GOLD PARK HOMES

KLEINBURG GLEN VAUGHAN, ON

SITE PLAN

SITE PLAN REVIEW

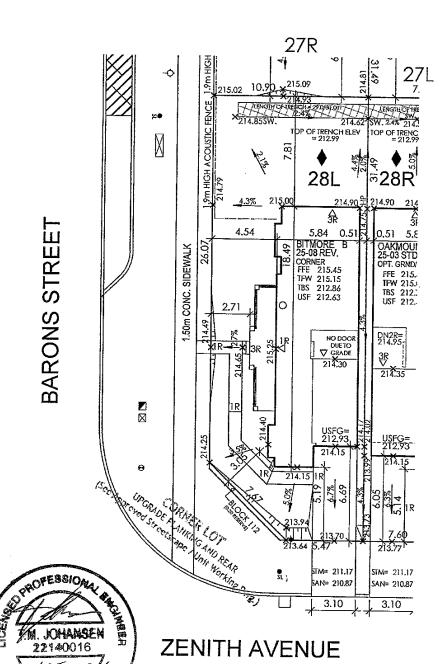
THE PROPOSED LOT GRADING AND DRAINAGE IS APPROVED AS BEING IN CONFORMITY WITH THE OVERALL APPROVED GRADING PLANS FOR THE SUBDIVISION.
